PLANNING & DEVELOPMENT
CITY OF NEWARK

December 6, 2018

The City of Newark's Subdivision Advisory Committee has reviewed the subdivision application for 511 Valley Road you submitted September 7, 2018.

Parcel # 1801700079
"511 Valley Road"

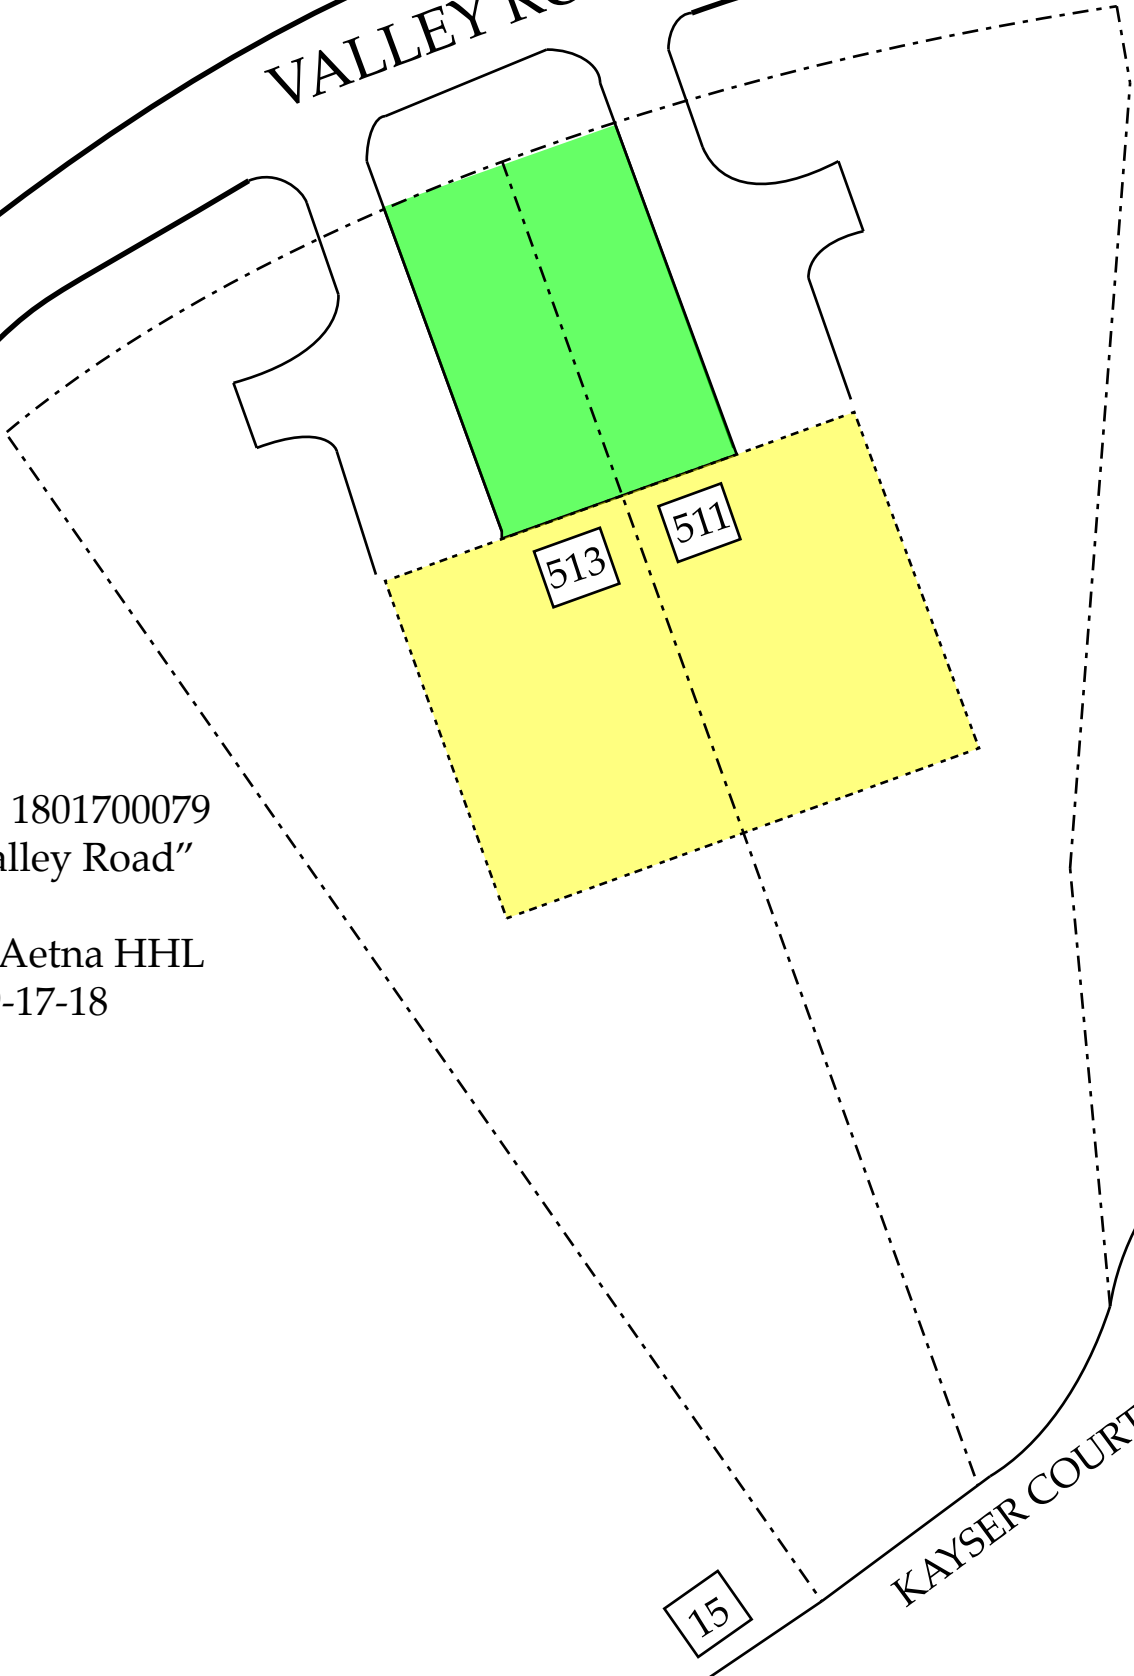
1. The plans should include the new address of the proposed lots. See the attached address map provided by the Newark Police Department and Aetna.
